TRES VAQUEROS WINDFARM PROJECT

Final Environmental Impact Report

Contra Costa County
Department of Conservation
and Development

October 2011

Tres Vaqueros Windfarm Repowering Project . 209132.02
Figure 3-2b (REVISED)
 Ownership of Wind Rights with the Repowered Project

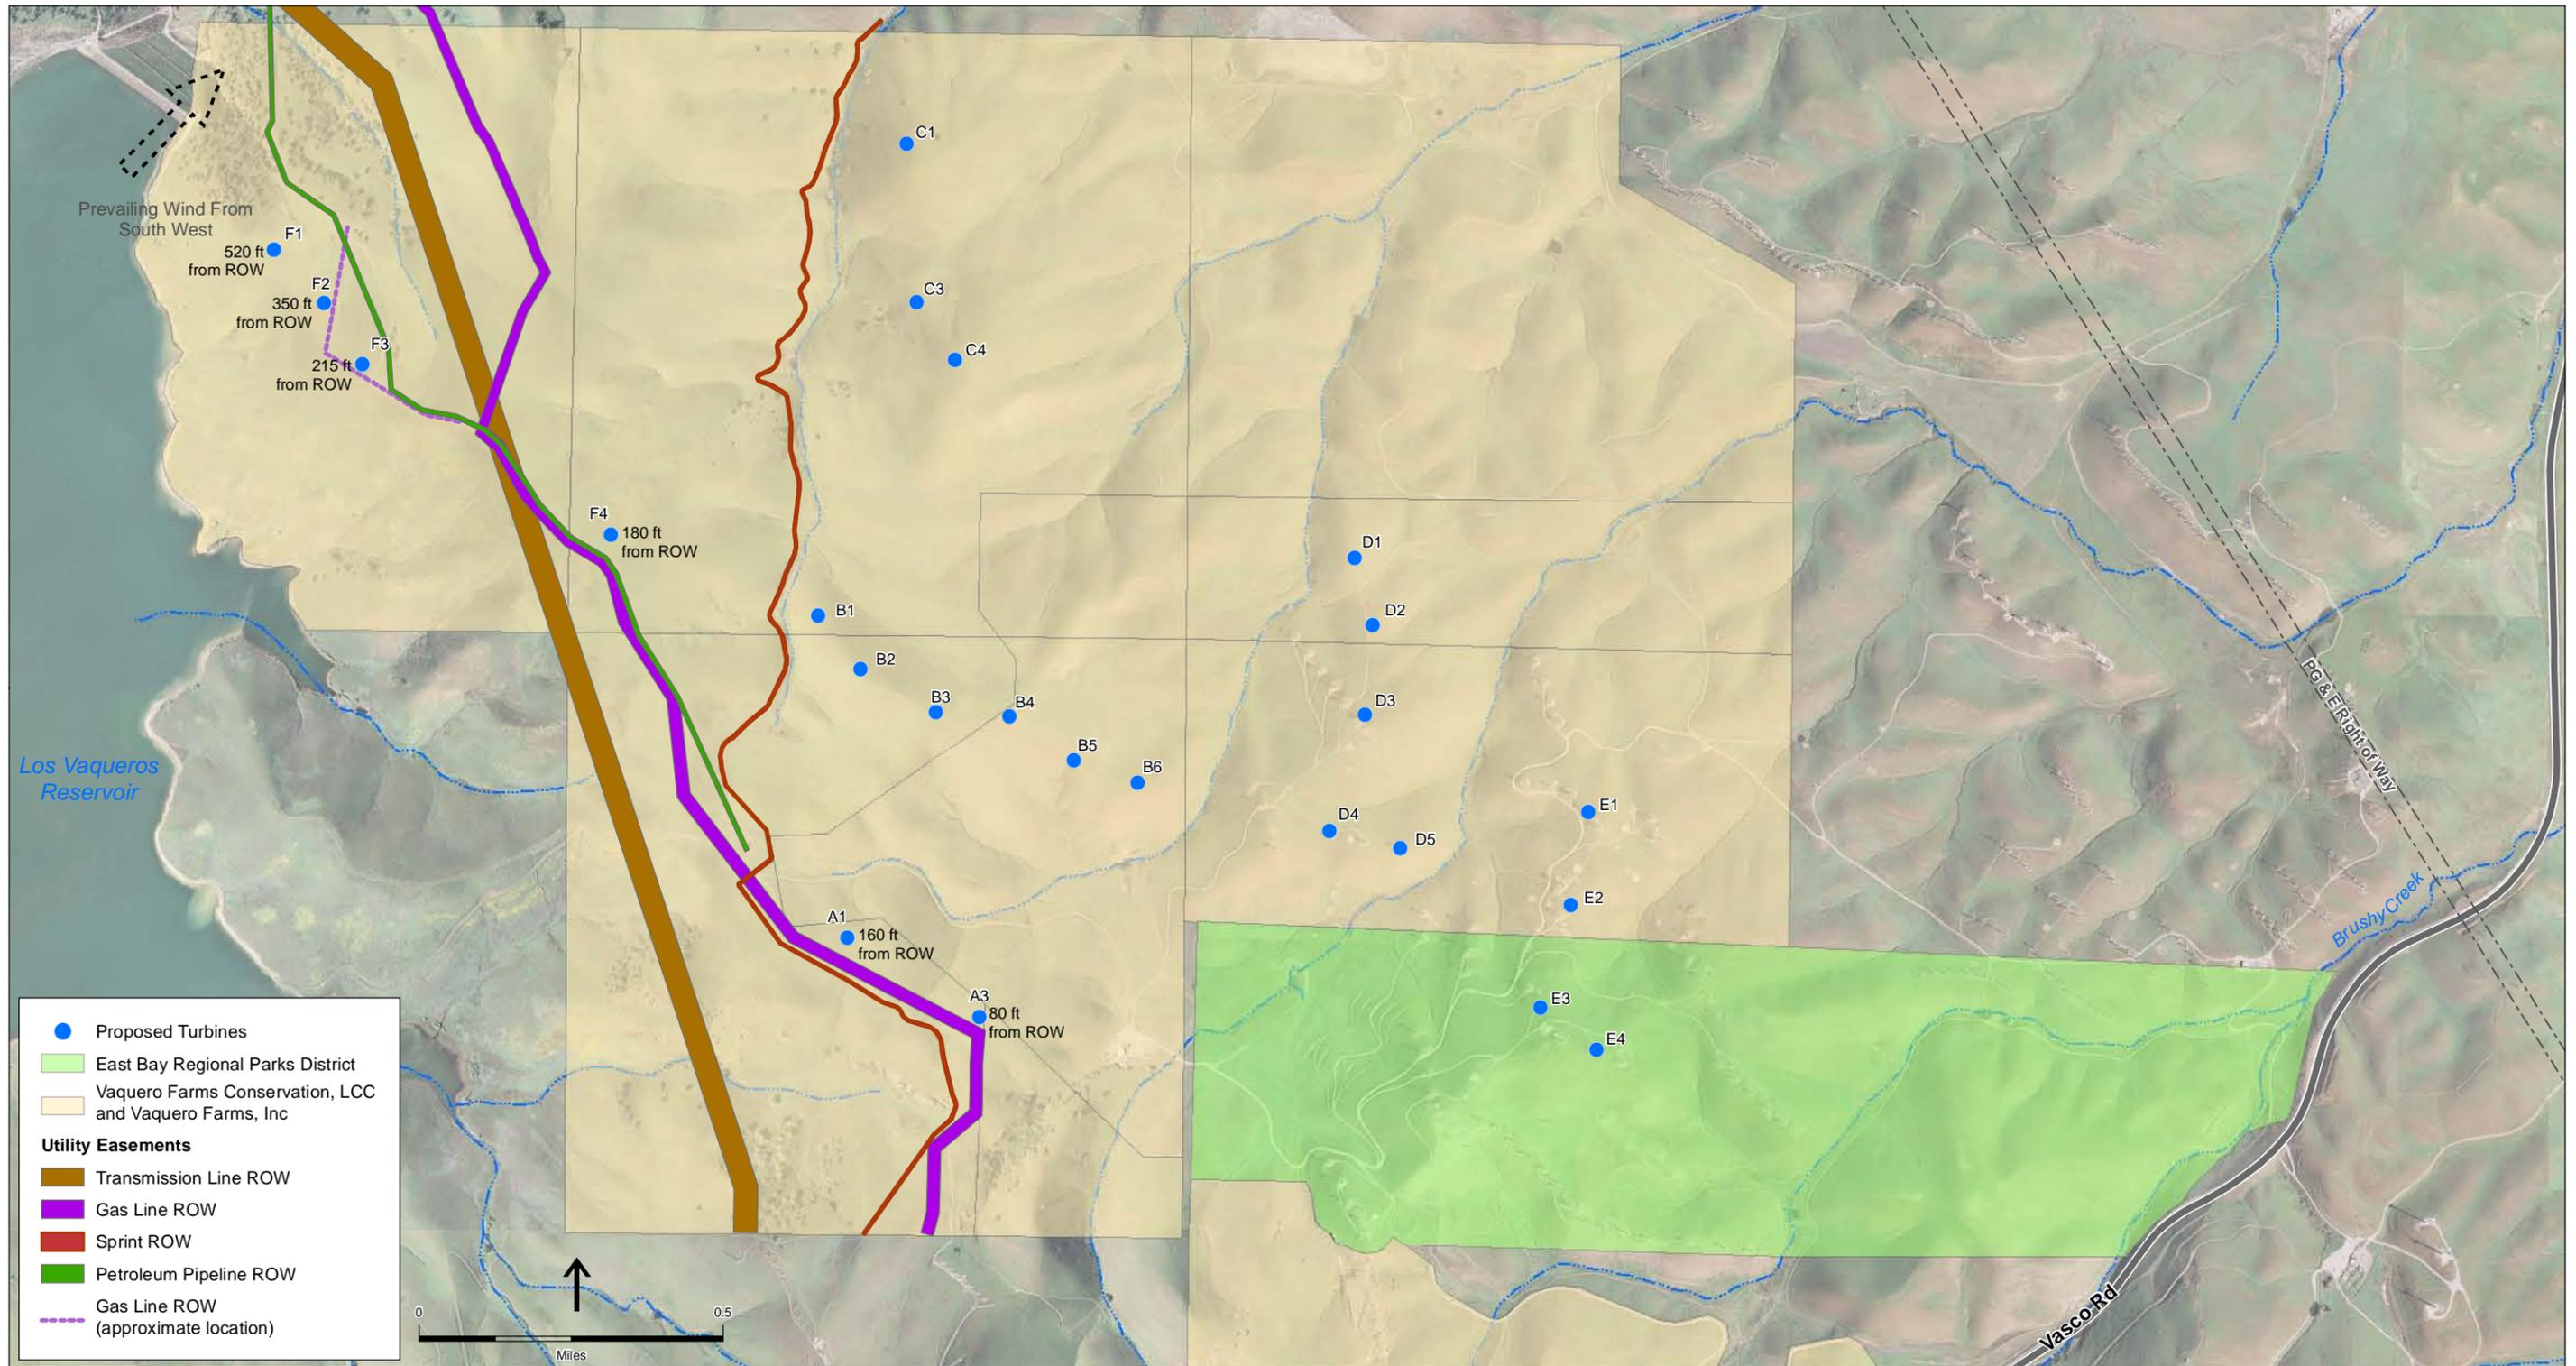
H-1 The commenter requests clarification on what rights EBRPD and CCWD have with regard to repowering. Table 3-1 of the DEIR identifies the owner of each parcel and the owner of the wind rights on each parcel. DEIR Figures 3-2a and 3-2b show the property ownership and the wind rights ownership within the Project Area, respectively. The County has updated DEIR Figure 3-2b (see Revised Figure 3-2b, below) to show the revised approximate area of Tres Vaqueros wind rights, as well as utility easements within the Project Area. The principle difference is that the revised figure no longer shows the Tres Vaqueros wind rights extending over Los Vaqueros Reservoir or its dam. Note that Tres Vaqueros wind rights are not severed by the utility easements and that the Project would not construct wind turbines within those easements.

The question of the legal rights as between the property and wind rights owners is a question of property law that is beyond the scope of CEQA. Nonetheless, the County understands that under various easements, leases and orders creating and/or recognizing these various property interests, the wind rights owners possess the exclusive and perpetual right to construct, maintain, and operate wind energy facilities on these lands.

In the case of the 936 acres under a conservation easement on a portion of EBRPD land, the easement recognizes the right of the wind rights holder to construct new wind facilities (e.g., repower) “provided that the overall square footage of the repowered project is not increased over above the square footage of the existing leases.” On the remainder of the EBRPD land not under the conservation easement, the wind rights owners have the ability to repower under existing leases. Regarding the CCWD land, in the Amended Final Order of Condemnation on the CCWD land, the court reserved to Vaquero² “all rights for wind energy power conversion and the transmission of power generated from wind.”

To summarize, EBRPD is a contractual party to wind development leases, which leases include the right to repowering of wind facilities. Those same repowering rights are recognized under the conservation easement. CCWD has agreed to reserve wind rights, both for new and repowered turbines, to Vaquero as part of the proceedings when CCWD condemned Vaquero’s property.

PROPOSED TRES VAQUEROS WINDFARM REDEVELOPMENT WAKE TURBULENCE ZONE COMPARISON

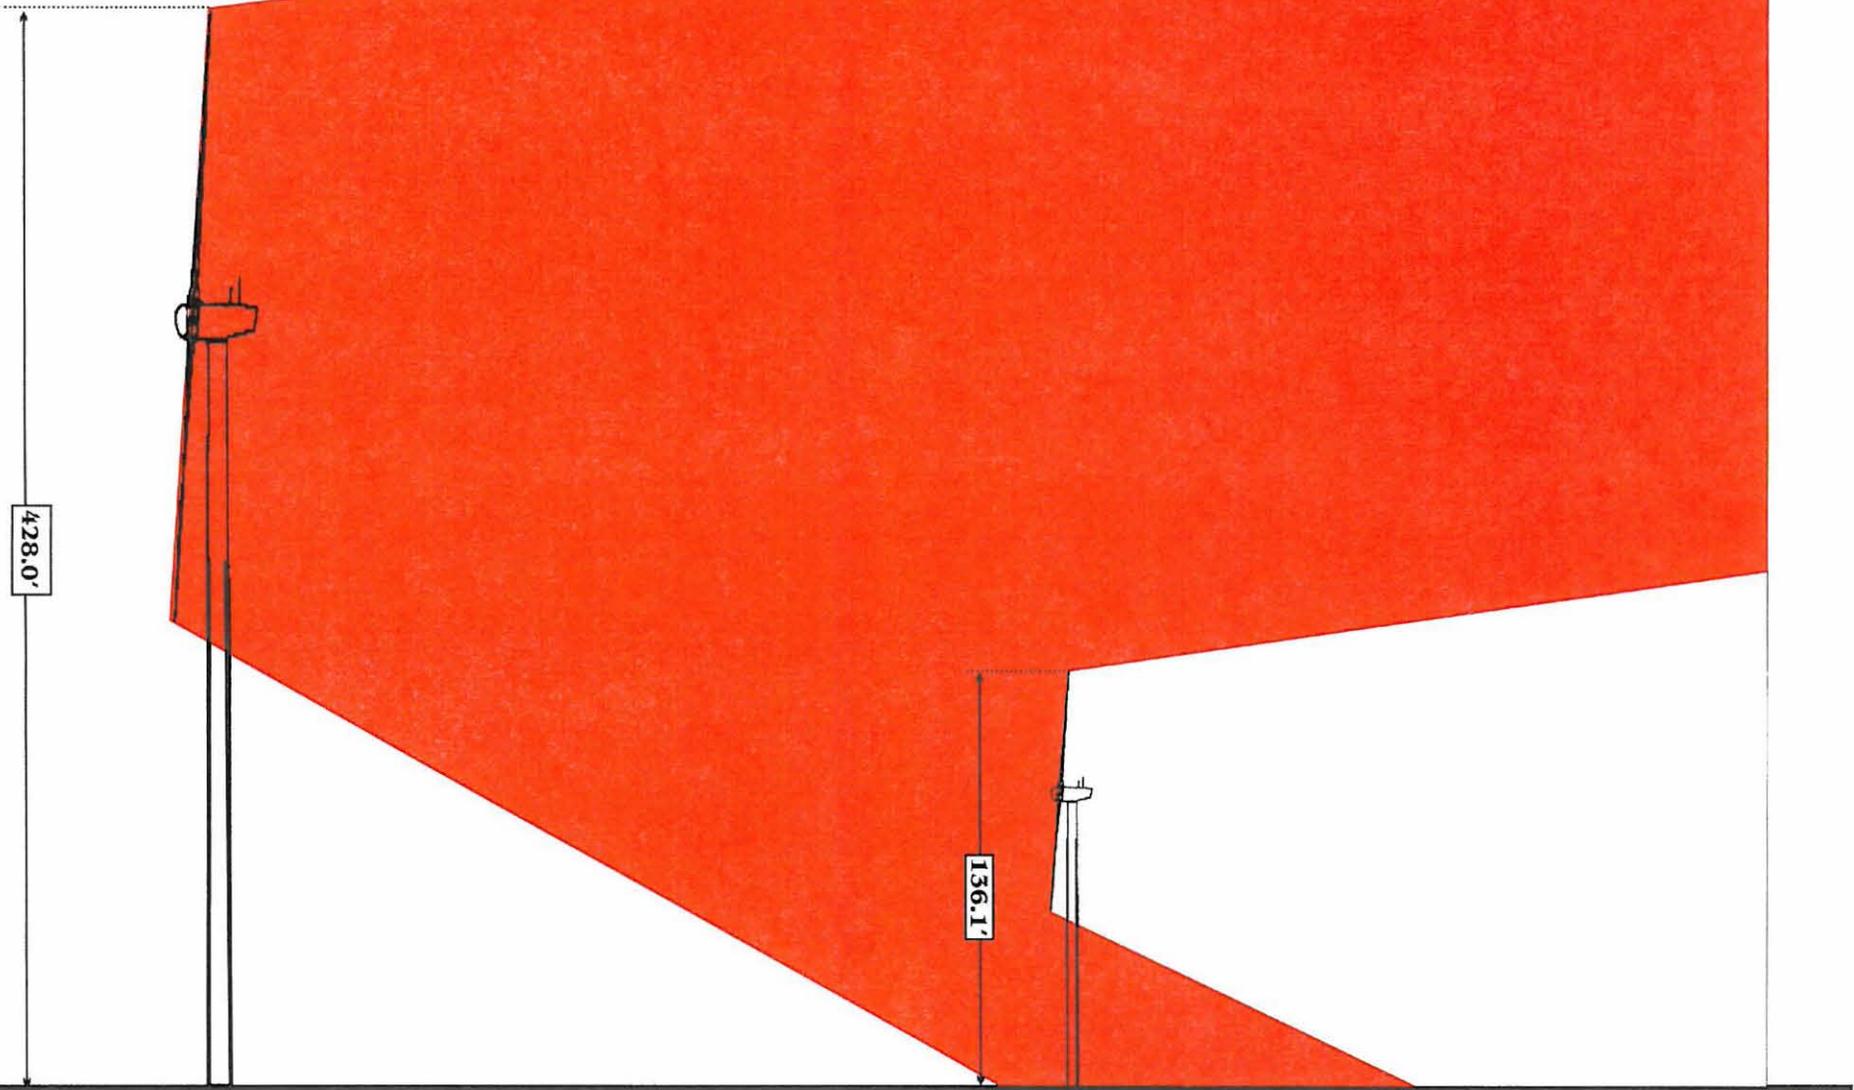
Second, even if a 2008 baseline could be used, the analysis in Chapter 4.6 would be inadequate. At Table 4.6-1, the Draft EIR assumes that all 60 turbines that operated at the Tres Vaqueros Windfarm in 2008 were upwind of the Northwind facility and near enough to cause downwind effects. A review of Draft EIR Figure 3-2a, together with the small size of the first-generation Howden turbines installed at Tres Vaqueros, demonstrates that this was not the case. Not only were many of the Howden turbines not near and not upwind from the Northwind turbines, but they were much smaller; enclosed are figures prepared by Northwind that show the size of the first-generation Howden turbines formerly operated at the Tres Vaqueros site compared to the Project's proposed turbines. To compare the swept area of all 60 turbines, many of which would not have affected the Northwind facility, to the swept area of four enormous new turbines, all of which would affect Northwind, is not an apples-to-apples comparison. A comparison of the upwind turbines actually operating in 2008 to the upwind turbines included in the Project would not show a "beneficial" effect on Northwind's facility.

Tres Vaqueros Windfarm Repowering Project . 209132.02
Figure 3-2b (REVISED)
 Ownership of Wind Rights with the Repowered Project

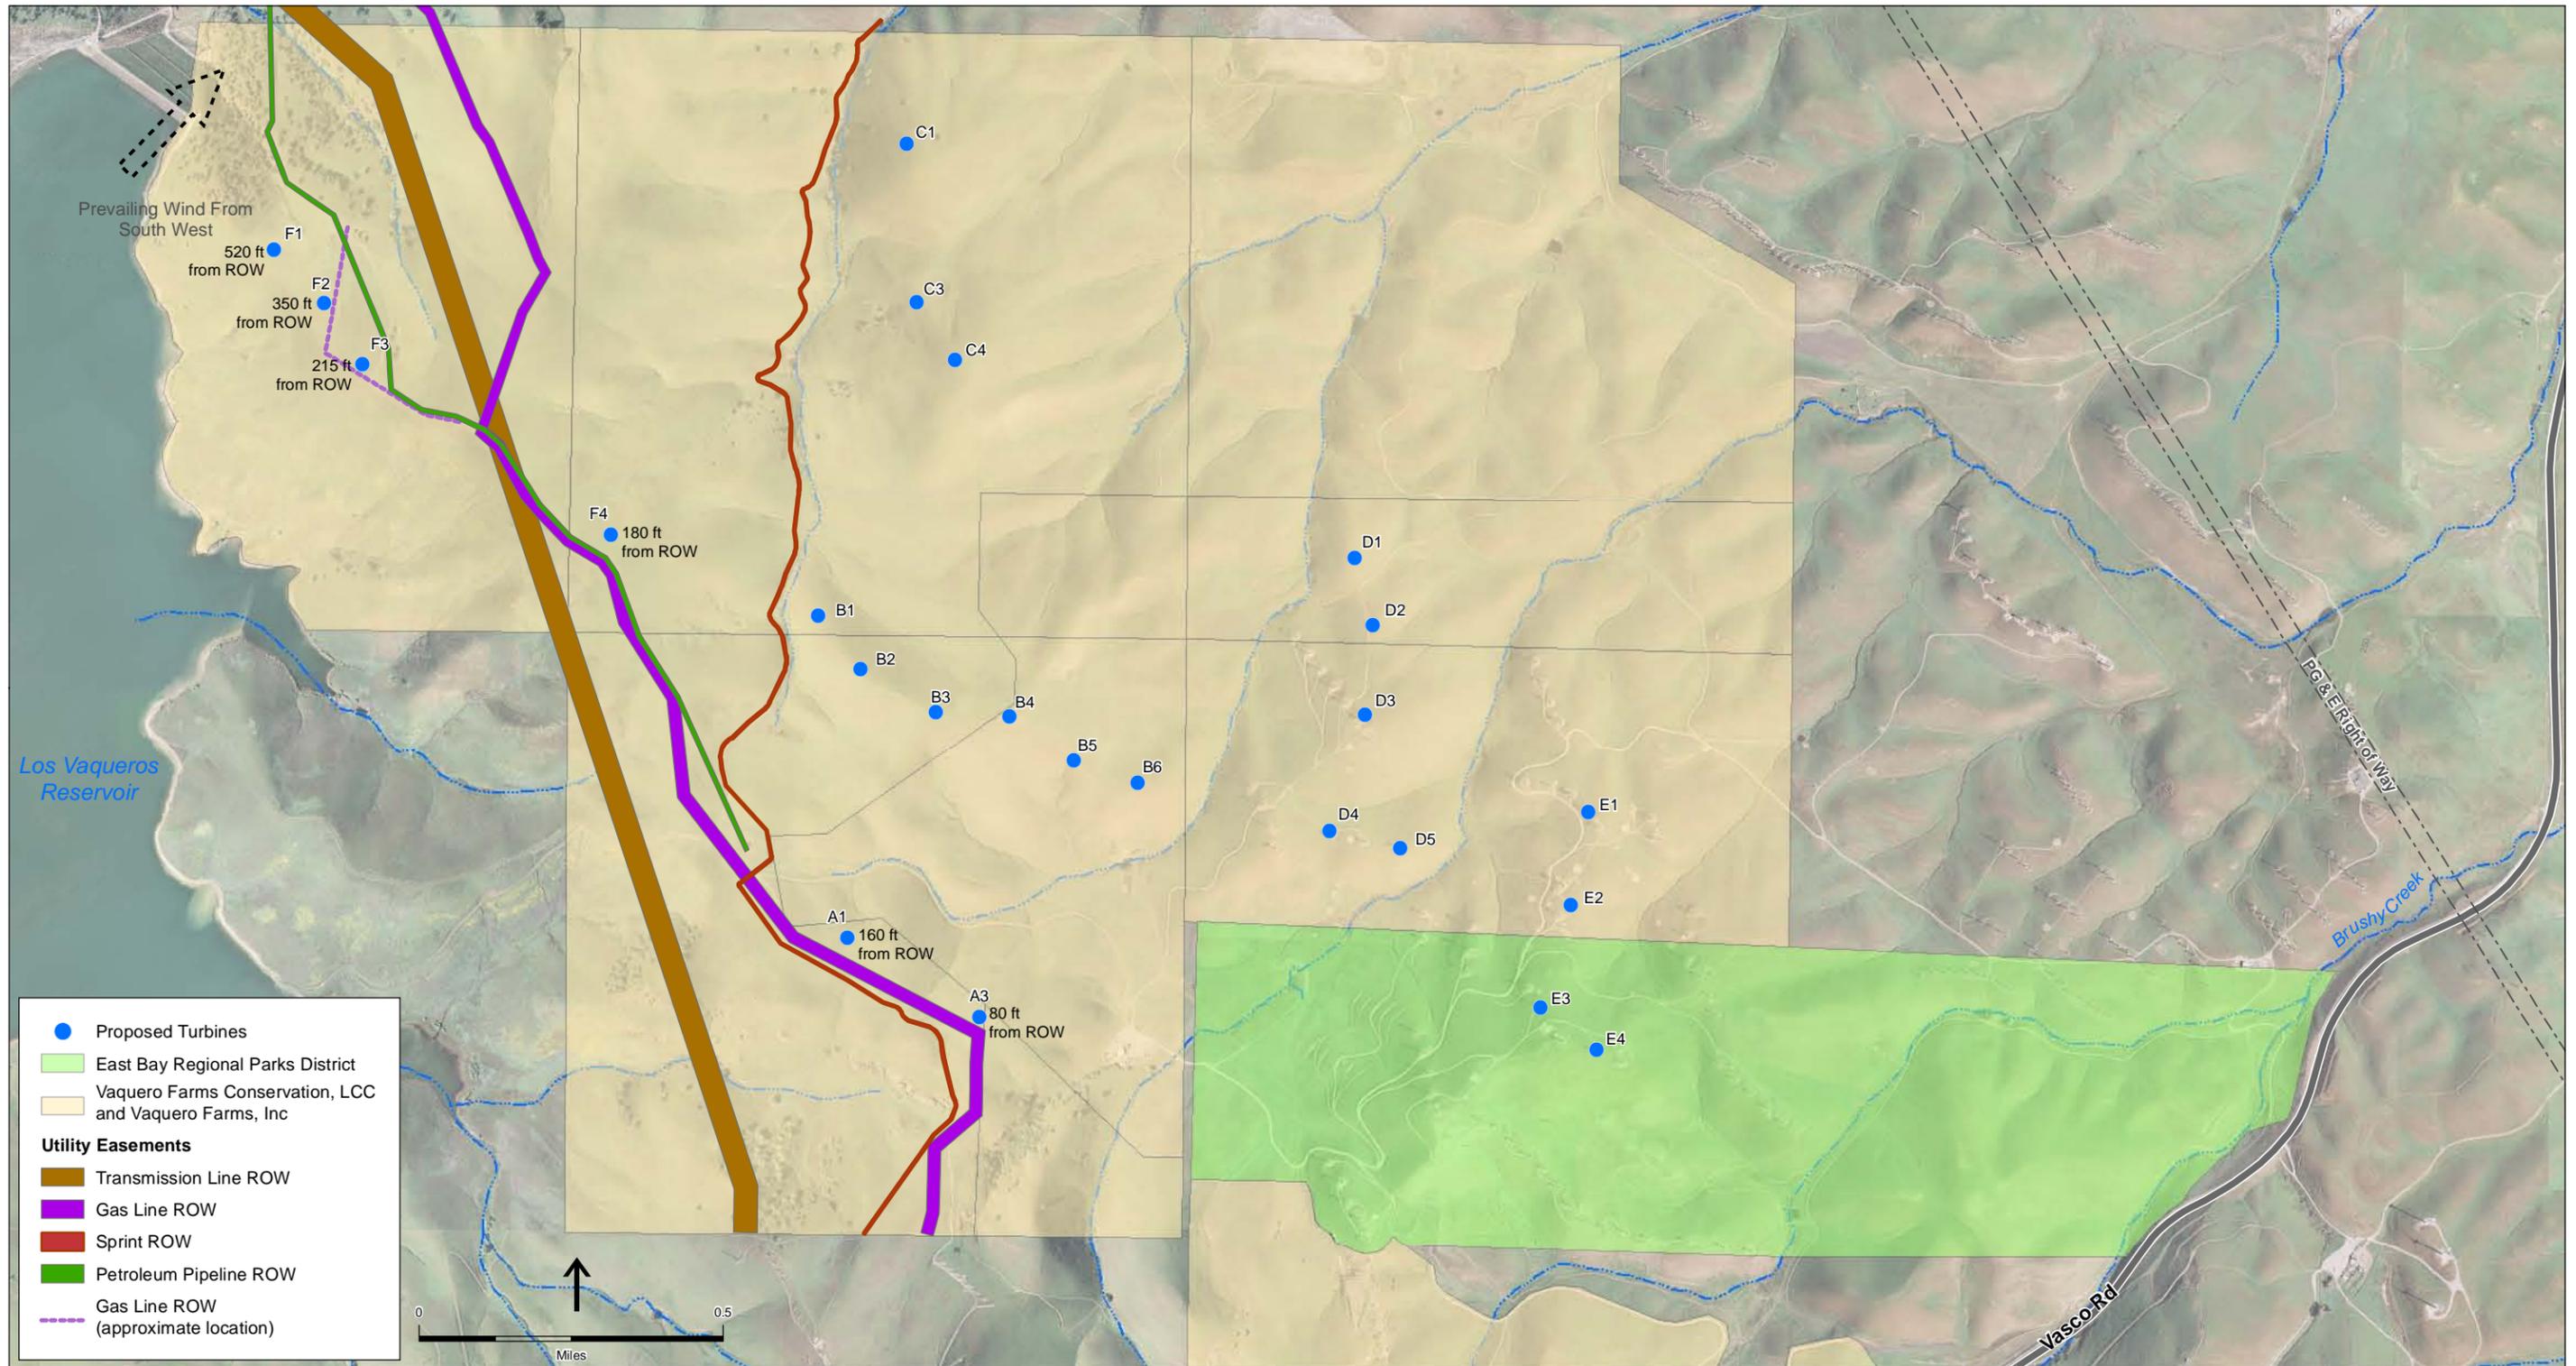
The County has made the following changes to Figure 3-2b in the DEIR to show the revised approximate area of Tres Vaqueros wind rights, as well as utility easements within the Project Area. Note that Tres Vaqueros wind rights are not severed by those easements and that the Project would not construct wind turbines within those easements.

Replace page 3-6 of the DEIR with the revised Figure 3-2b, as shown on the following page.
